ECE/TRANS/WP.29/GRE/2007/23
28 December 2006

REGULATION No. 48
(Installation of lighting and light-signalling devices)

Provisions for the installation of end-outline marker lamps

Proposal for draft amendments to Regulation No. 48

Figure 1

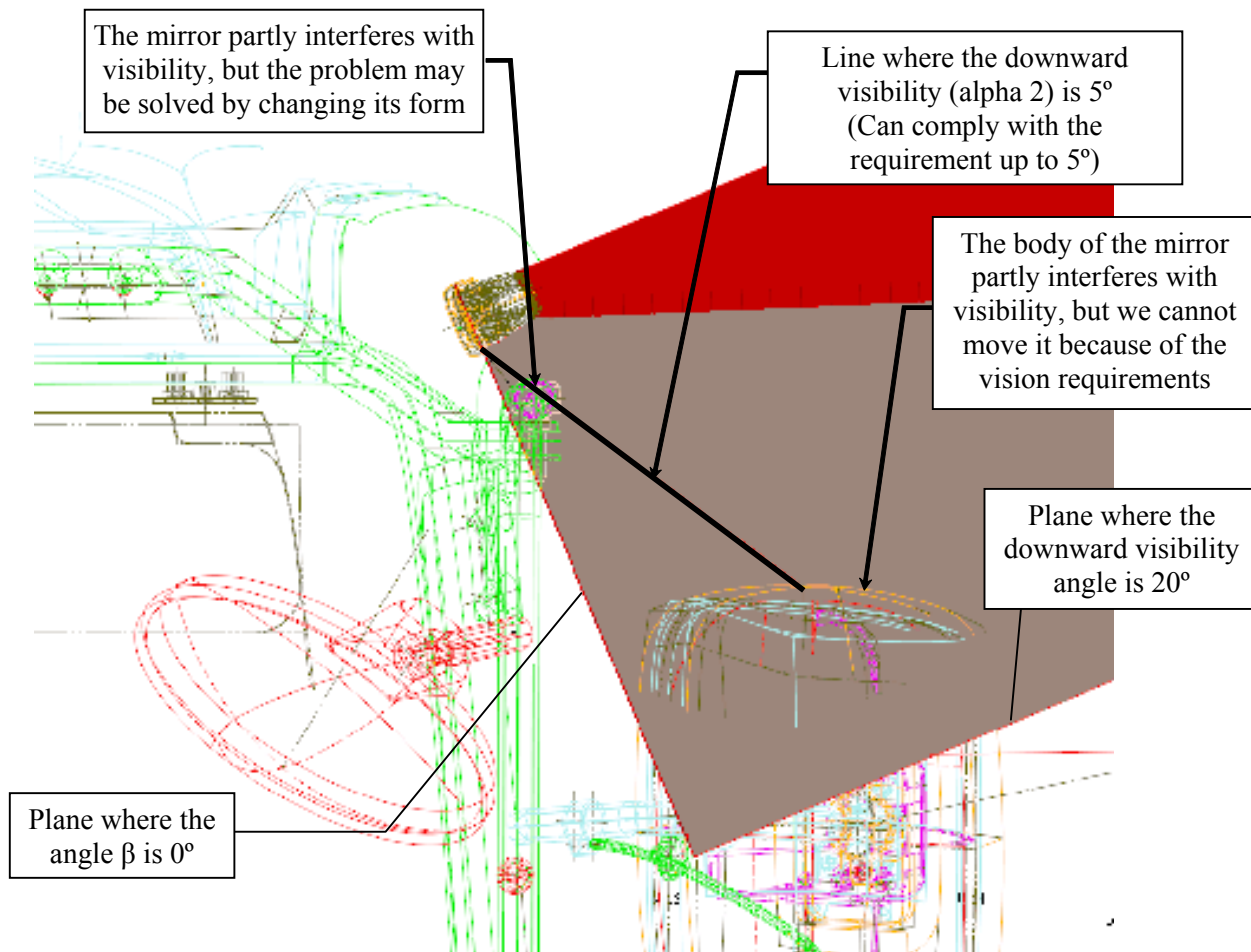
In cases of cab-over trucks, unlike vans, the cab itself is the highest position of the vehicle, therefore, the required downward visibility angle (alpha 2) between end-outline marker lamp and rear-view mirror cannot be fulfilled.

Japanese manufacturers of large-sized trucks had made experiments to study the limit of the angle of downward visibility (alpha 2) on cab-over trucks. The results showed that the limit was 5 degrees (see Figures 1 and 2).

Vertical angle: 5° above and 20° (**5° if the shape of the bodywork makes it impossible to meet the requirements for geometric visibility due to the installed rear-view mirror or other devices for indirect vision regulated by each Contracting Party**) below the horizontal."
